PASADENA LIGHT RAIL FINAL SUPPLEMENTAL EIR

Los Angeles County Transportation Commission

**PASADENA-LOS ANGELES LIGHT RAIL TRANSIT PROJECT
FINAL SUPPLEMENTAL ENVIRONMENTAL IMPACT REPORT (FSEIR)
STATE CLEARING HOUSE NO. 89082327**

FILLMORE STATION

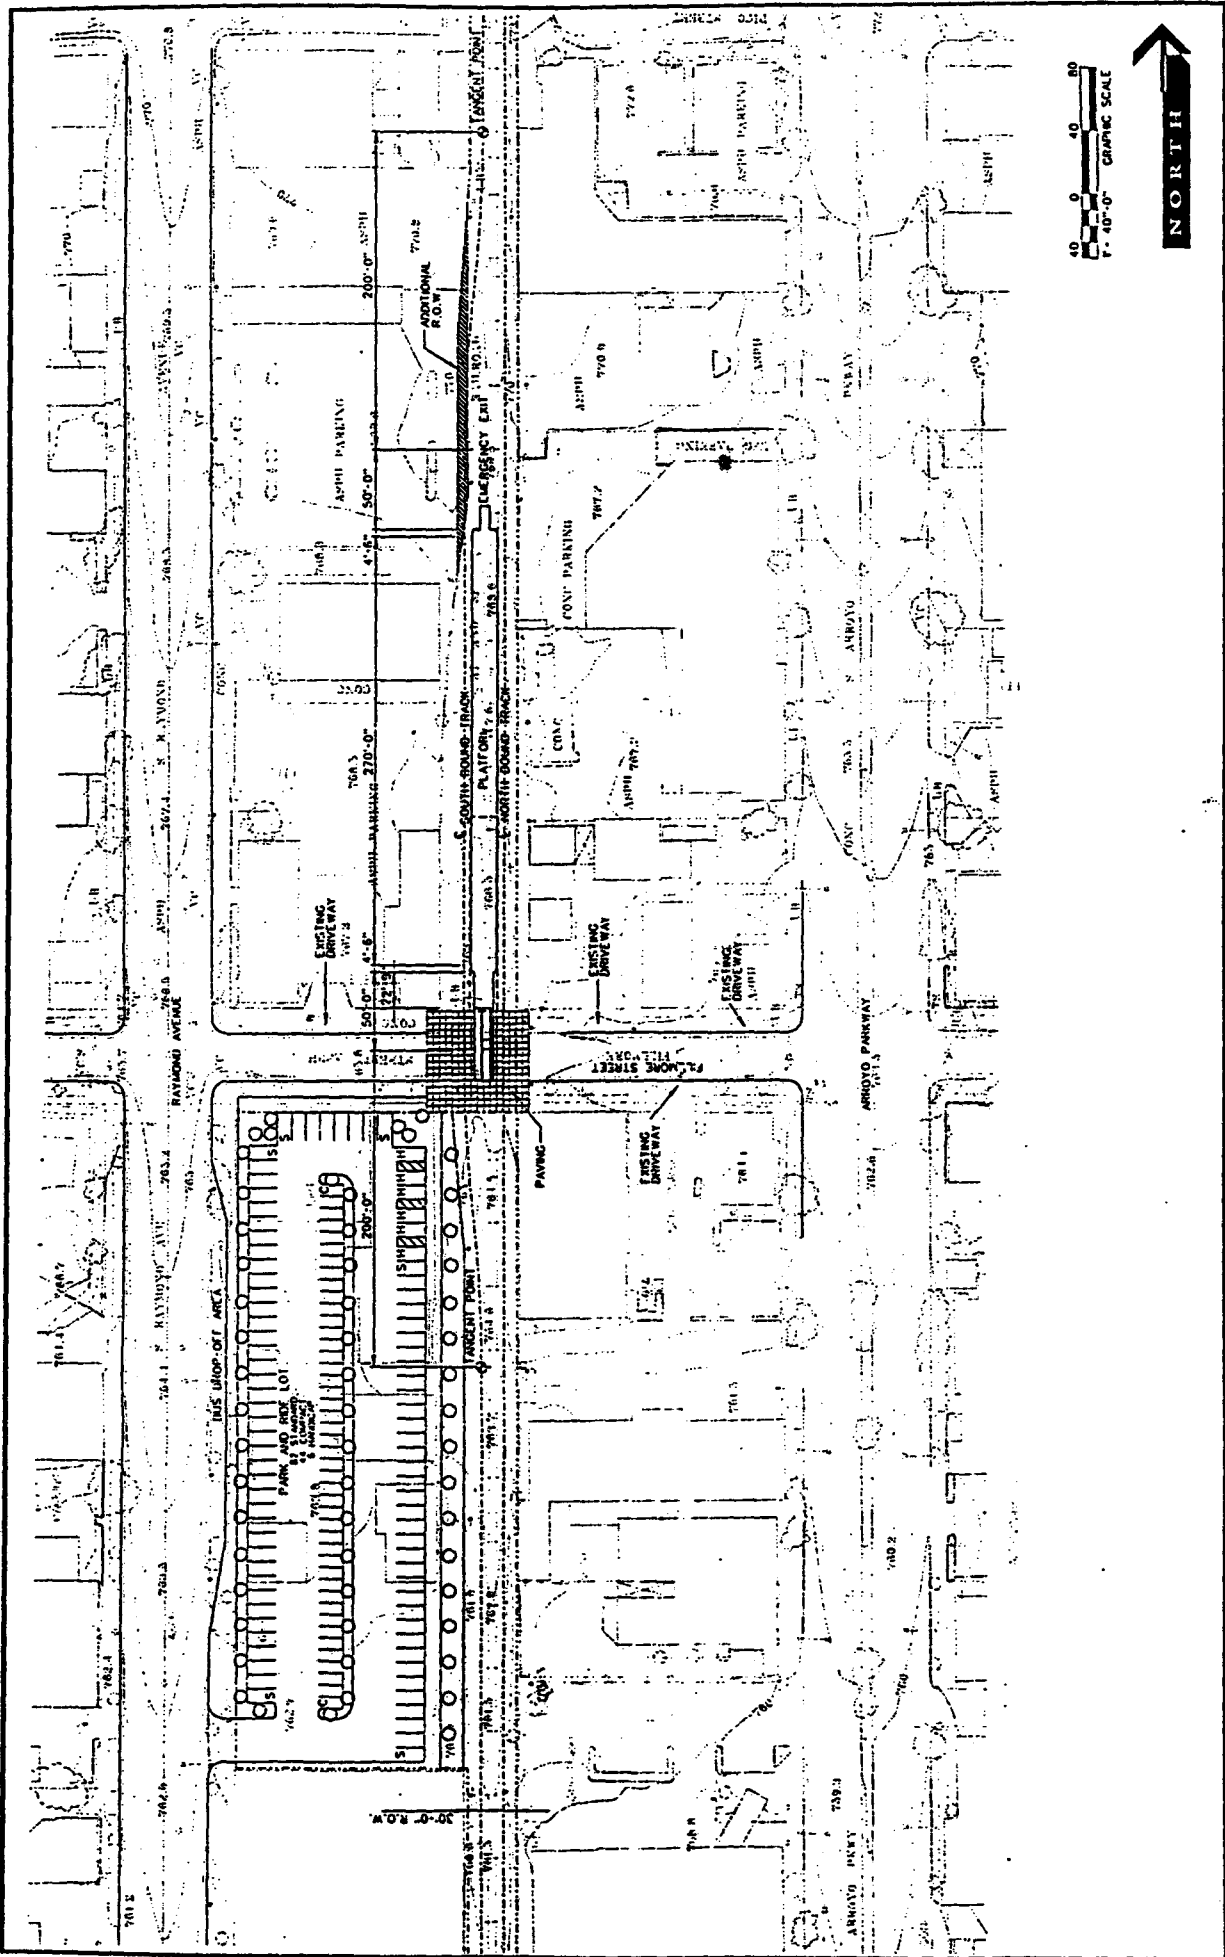
Comment 8: Exhibit 3.3.7 for the Fillmore Station needs to be revised to show that the station is located just north of Fillmore Street and not within Fillmore Street as shown on the Exhibit. In fact only the ramp area to the station will be in Fillmore Street, as shown by the latest drawings provided to the City by the RCC.

Page 3-8. Third paragraph, last sentence, replace the work "side" with the word "center." Add: "see revised Exhibit 3.3-1." Exhibit 3.3-7 follows this page.

exhibit
 3.3-8

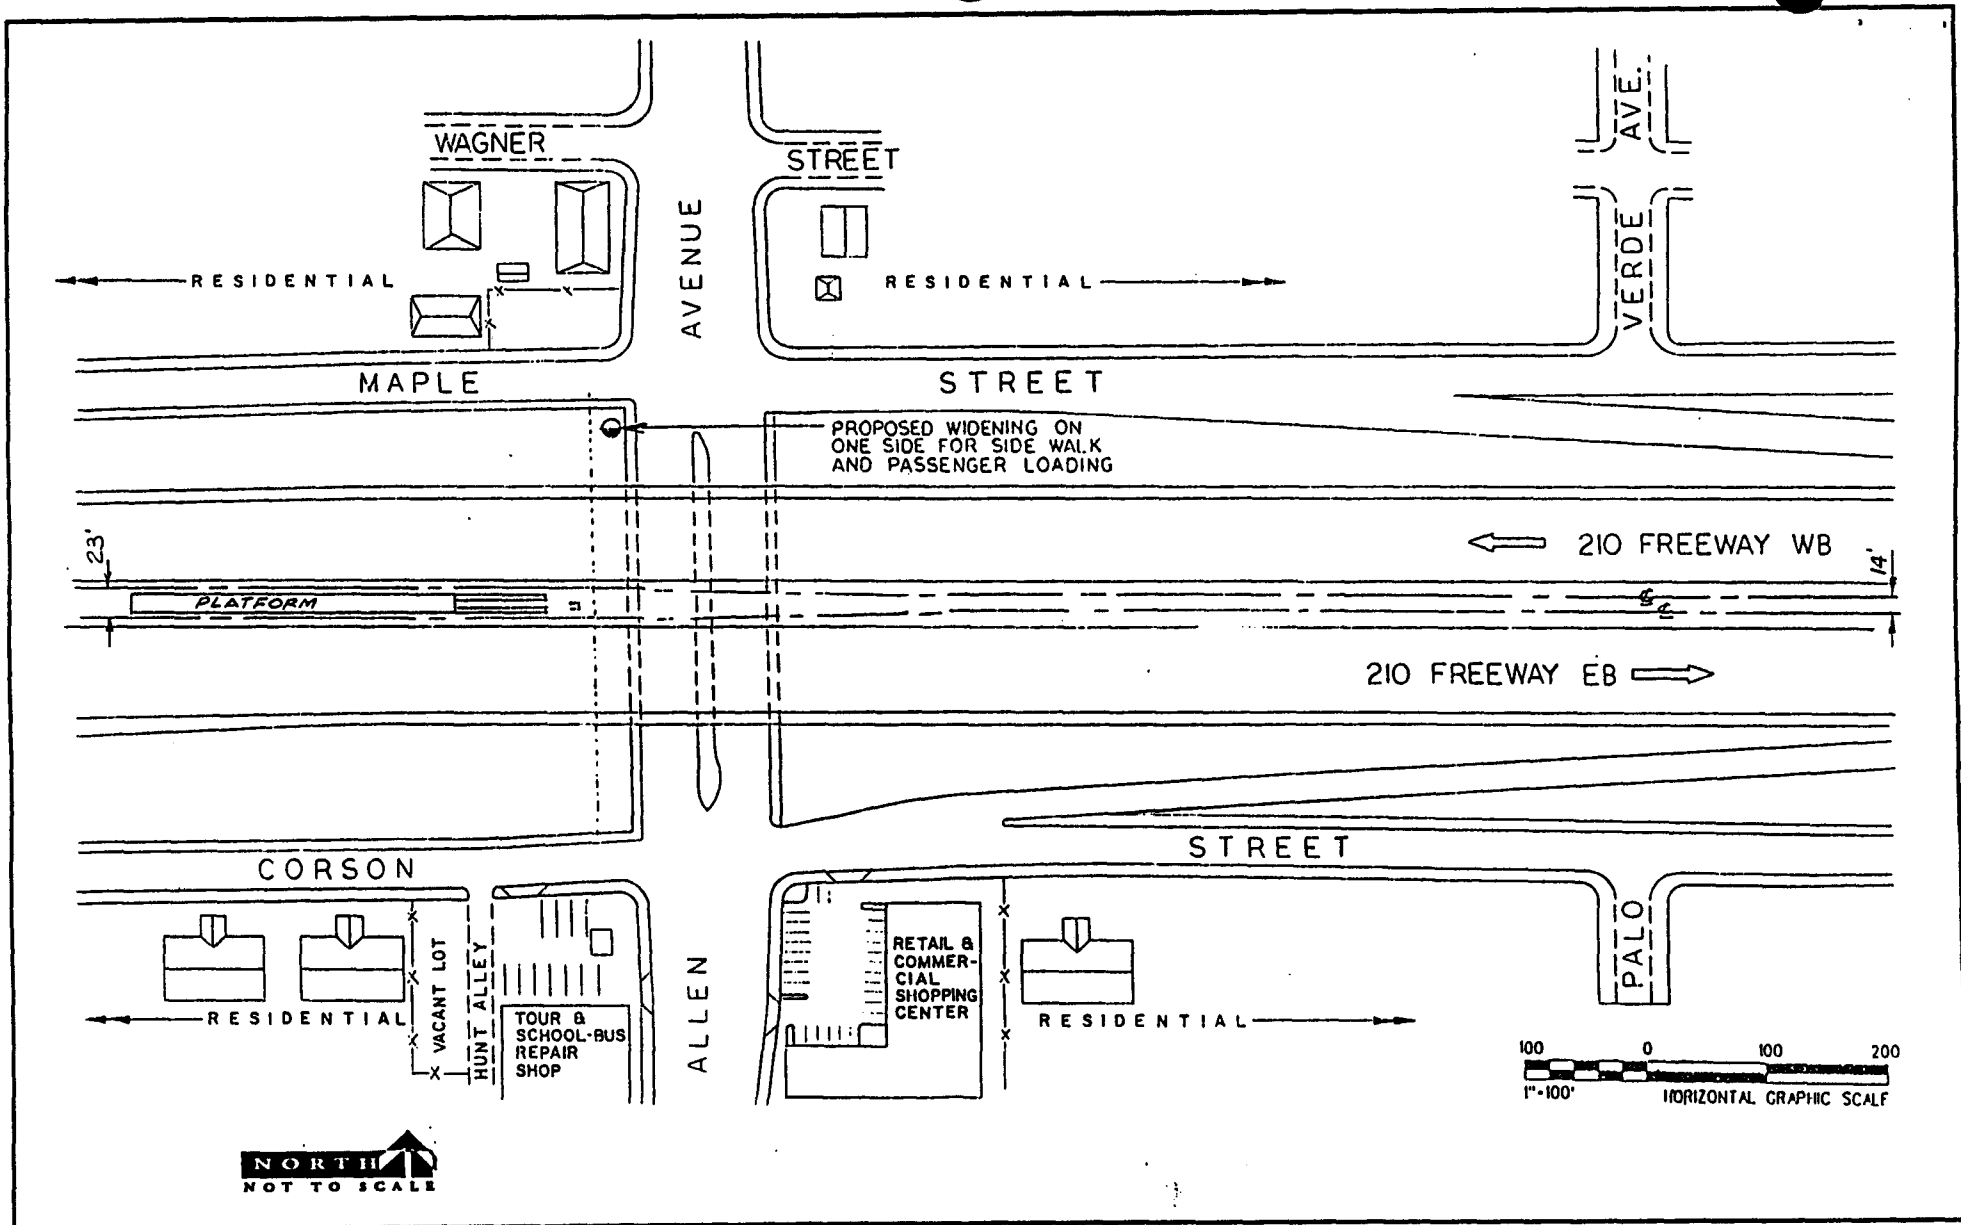
Comment 7: Exhibit 3.3-8 needs to be revised to indicate that the Allen Avenue Station is to be located just west of Allen Avenue and not east of Allen Avenue as shown on the exhibit. In addition, the proposed widening indicated needs to be revised as it has been determined no widening will be required on Allen Avenue.

Page 3-9. Last paragraph after the second sentence add: "The intersections of Union Street/Colorado Boulevard and Green Street/Colorado Boulevard will be traversed by the subgrade alignment. Refer to Exhibit 3.3-9." Exhibit 3.3-8 has been revised to indicate that the Allen Avenue Station is to be located just west of Allen Avenue and not east of Allen Avenue. Exhibit 3.3-8 follows this page.
